RE: CLIFFORD INDUSTRIAL PARK PROJECT NO. 5179.90, MAP NO. C-17

RE: CONCEPTUAL GRADING AND DRAINAGE PLAN FOR TRACT B-1-A-3,
CLIFFORD INDUSTRIAL PARK (C17/D1U), SUBMITTED FOR SITE
DEVELOPMENT PLAN FOR BUILDING PERMIT APPROVAL,
ENGINEER'S STAMP DATED 7/7/95.

RE: SUNDANCE (C17-D1U) GRADING & DRAINAGE PLAN AND S.O. 19

TO: Desiderio Salas, Street Maintenance Division
FROM: Lisa Ann Manwill, P.E. Engineering Associate, PWD *LAM*
SUBJECT: **PRIVATE DRAINAGE FACILITIES WITHIN PUBLIC RIGHT-OF-WAY
DRAINAGE FILE NUMBER C17-D1U.**

FIGURE 1

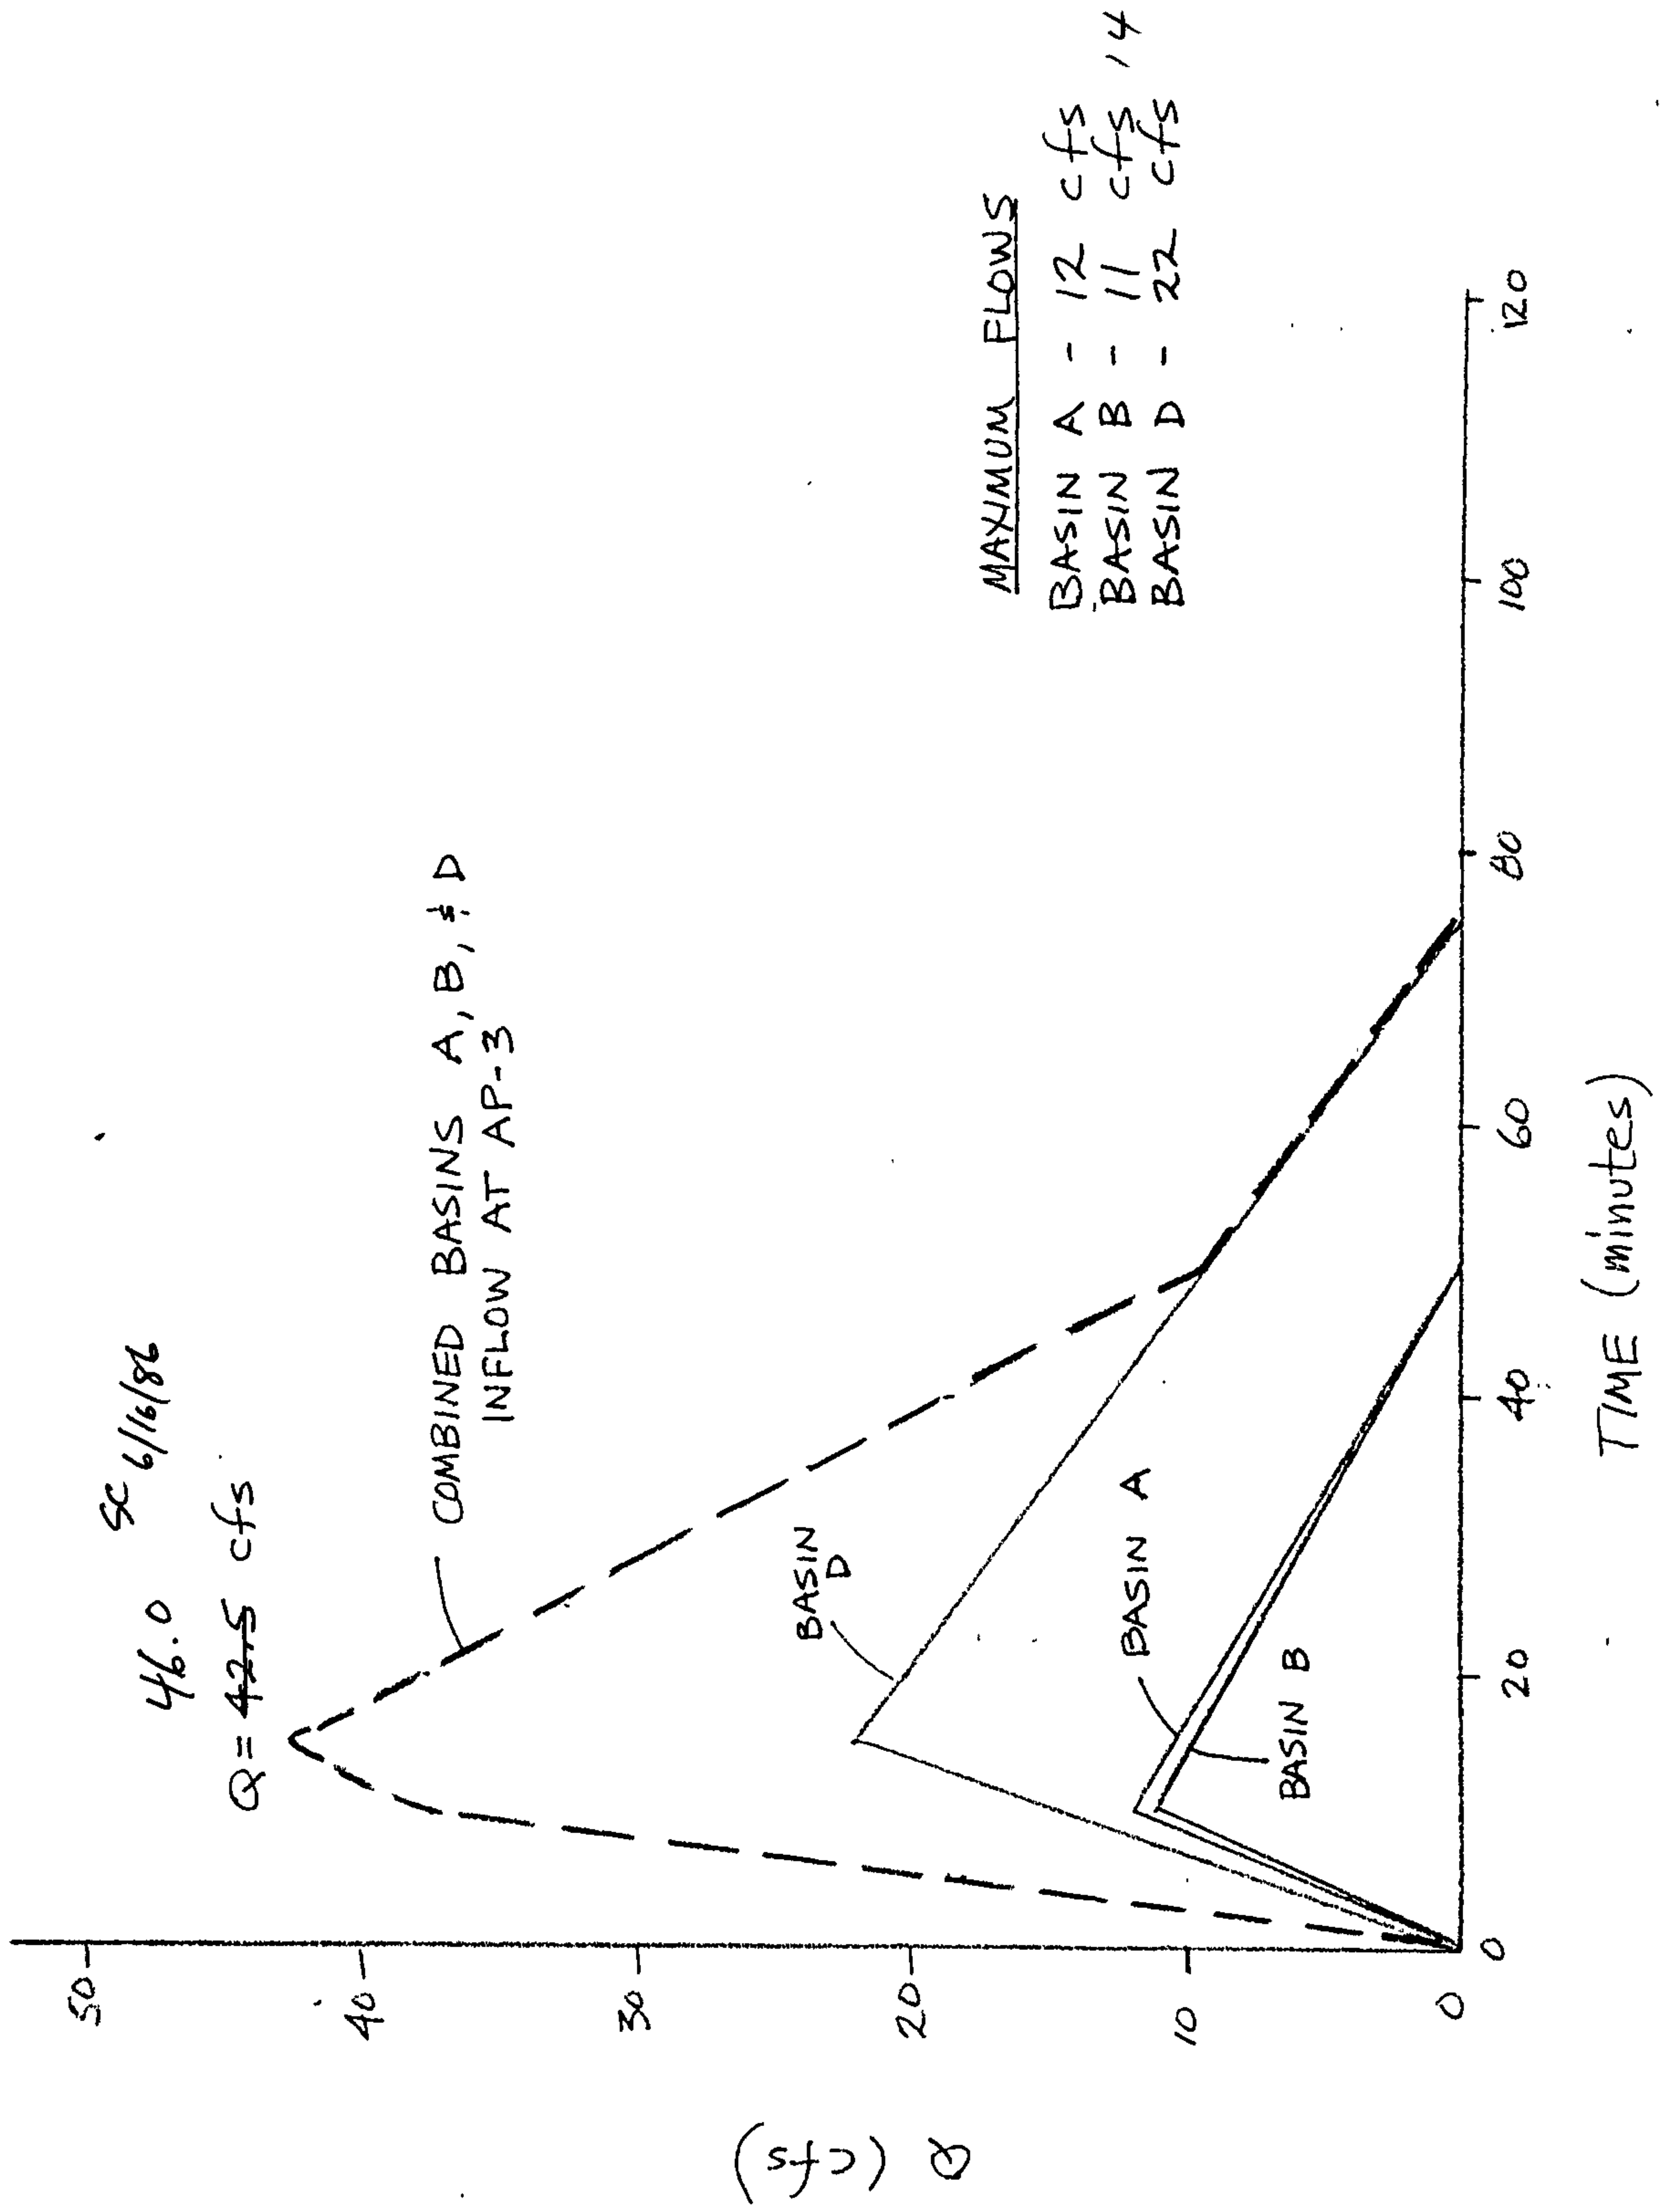
Analysis Point 2 - Runoff from Basins 'A' and 'B' combine at AP-2. The combined hydrographs at AP-2 (Figure 1) indicate a peak discharge rate of ~~23~~ cfs. These flows continue west to AP-3. *26 sc 6/16/86*

Analysis Point 3 - The combined runoff from Basins 'A', 'B', and 'D' discharge through AP-3 at a maximum rate of ~~43~~ cfs (see Figure 1). These flows then travel south to AP-4. *46 sc 6/16/86*

FIGURE 2

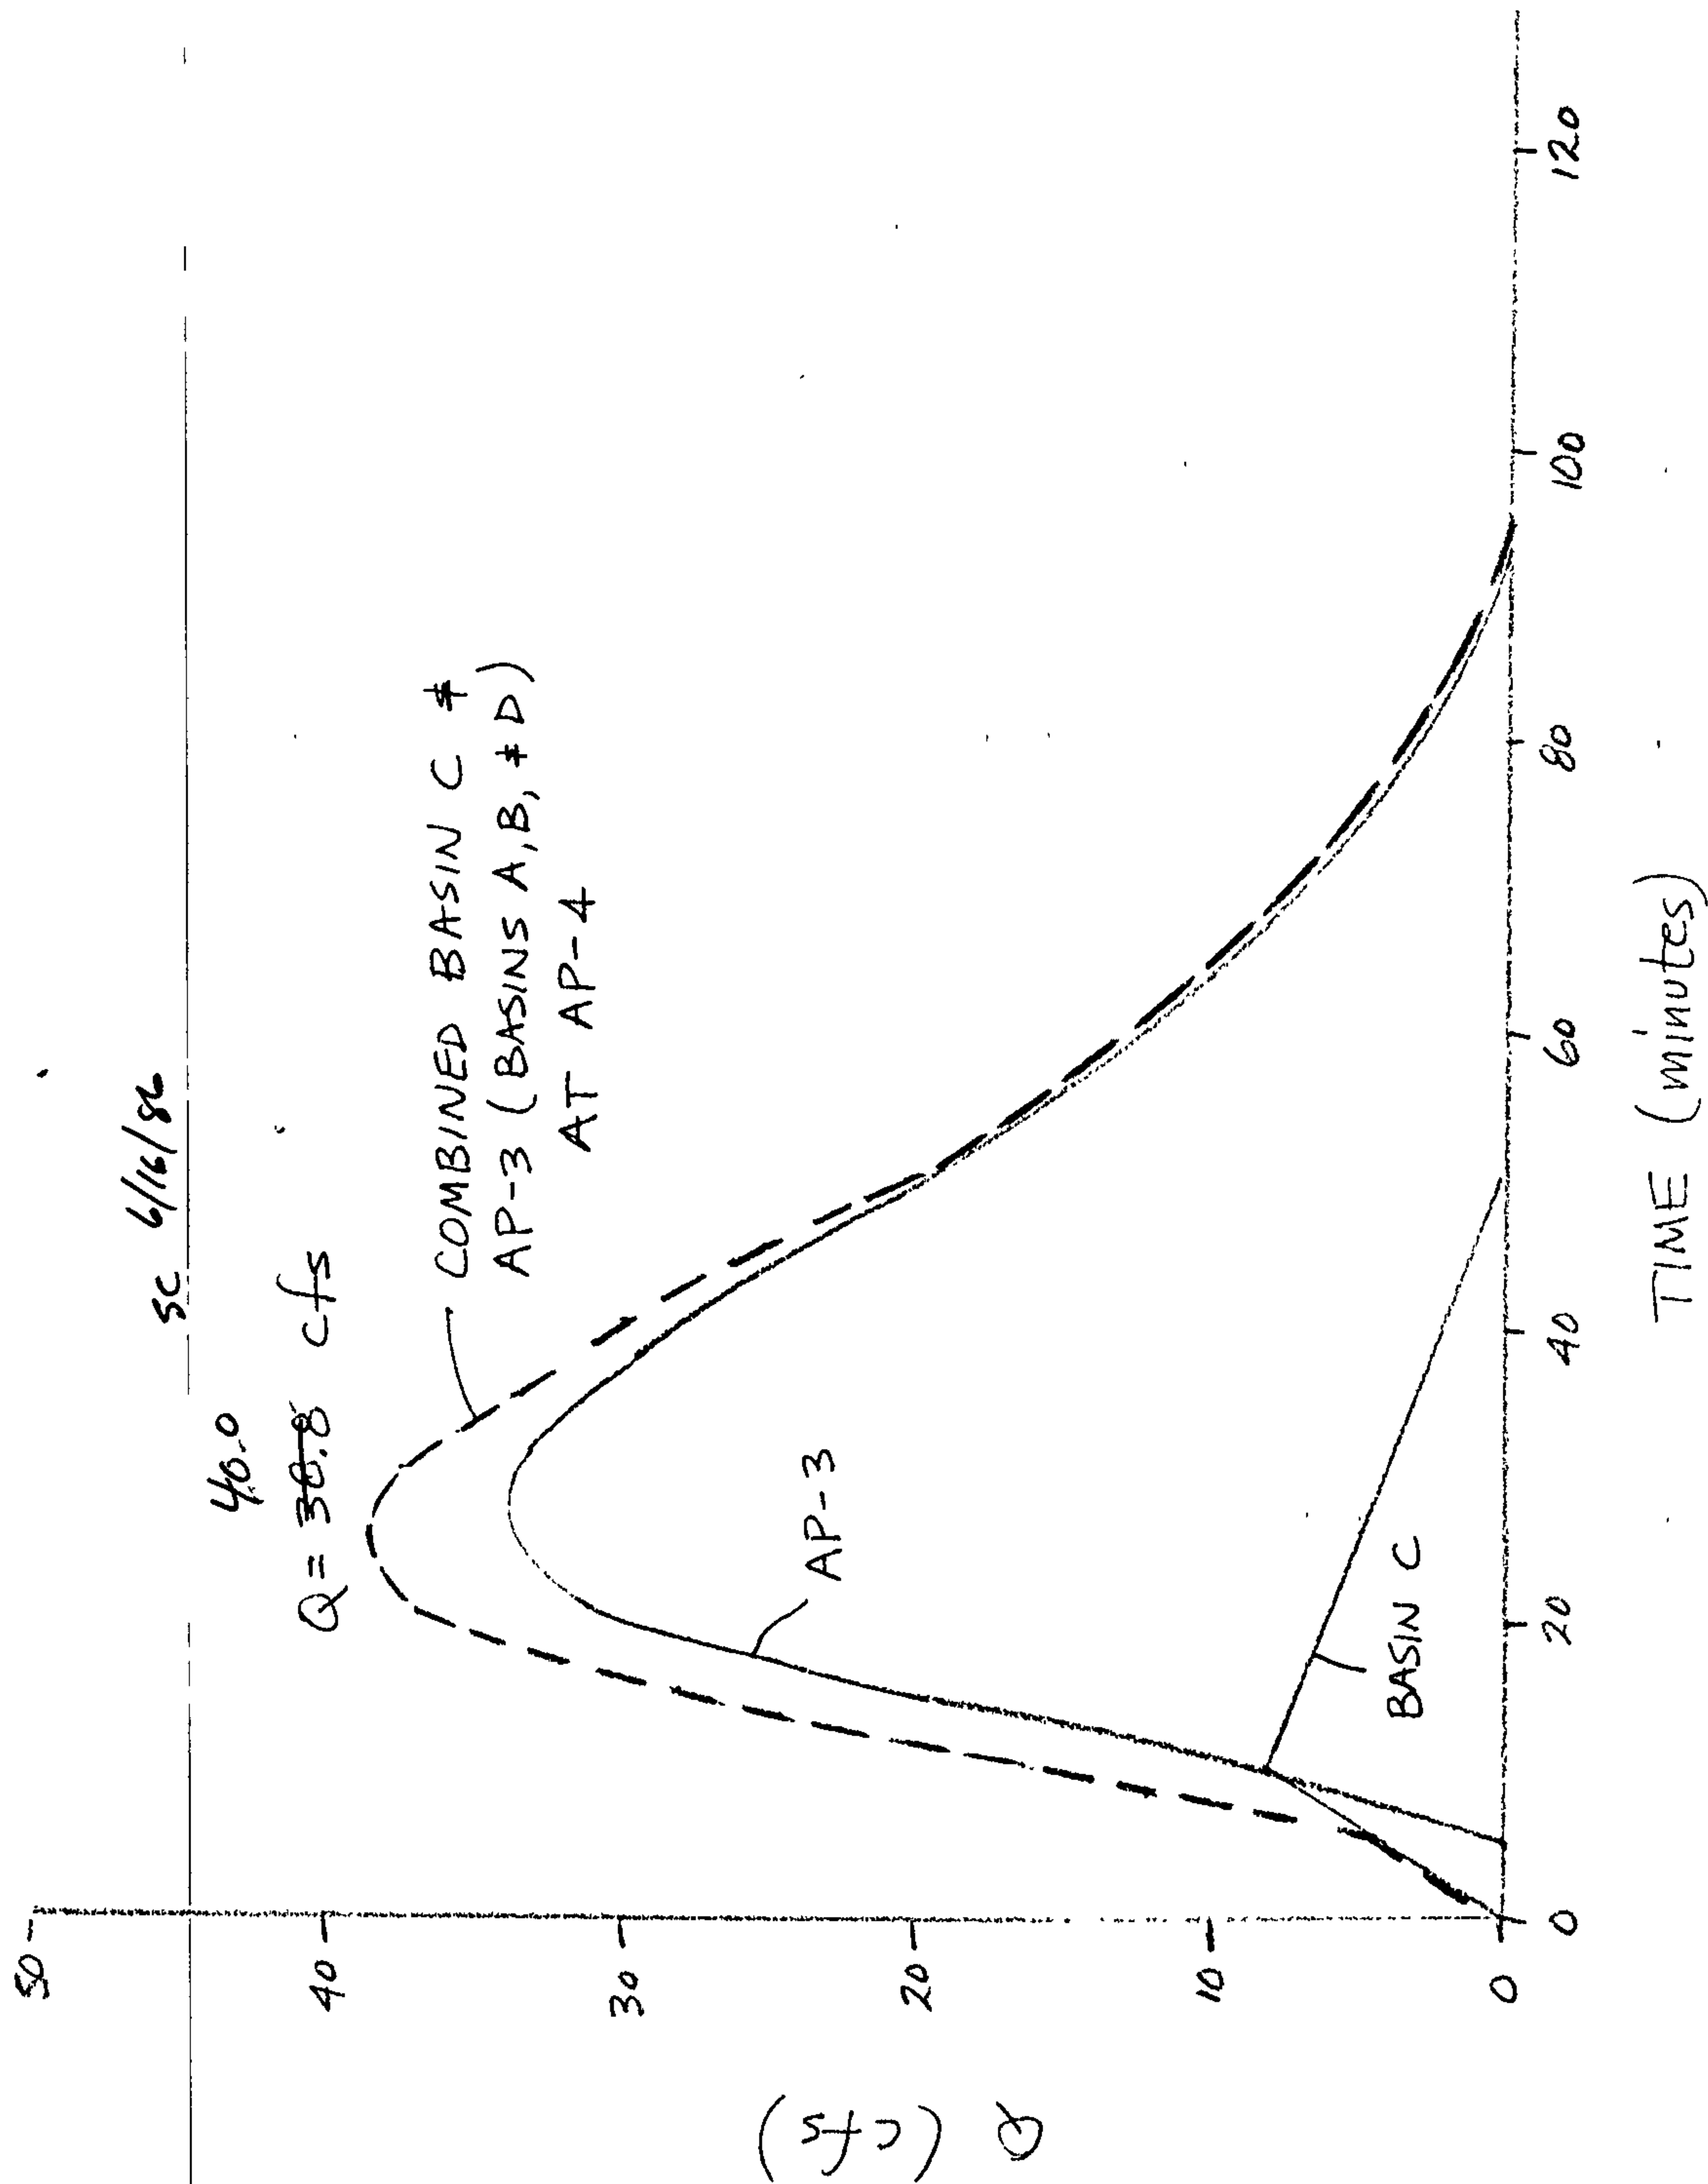
Analysis Point 4 - Discharges from Basins 'A', 'B', and 'D' (AP-3) combine with those in Basin 'C' and are routed in Swale 'A' southerly to AP-4. These flows discharge at a peak rate of ~~39~~ cfs (see Figure 2). From AP-4, flows discharge into the North Diversion Channel. *40 sc 6/16/86*
